Appl. No. 10/424,475
Amdt. dated January 9, 2006
Reply to Office action of November 7, 2005

Amendments to the Drawings:

Appl. No. 10/612,692
Amdt. Dated January 9, 2006
Response To Office Action Of November 7, 2005
"Marked-Up" Sheet

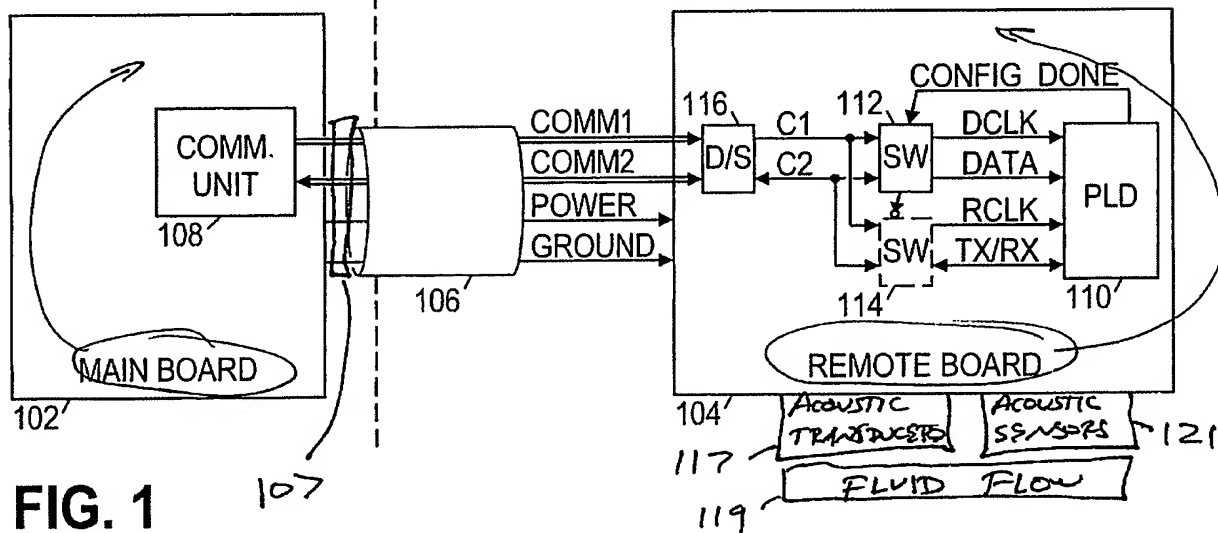
The examiner objected to the drawings under 37 CFR 1.83(a) for failing to show the command signal, acoustic transducer and fluid flow.

With respect to the acoustic transducer and fluid flow, Fig. 1 has been amended to show acoustic transducers 117 and fluid flow 119, as well as acoustic sensors 121. Support for these amendments can be found in ¶33 and claims 9, 17 and 23. Fig. 1 has been further amended to show an energy barrier 107, as described in ¶11. Applicants submit that the drawings now satisfy 37 CFR 1.83(a).
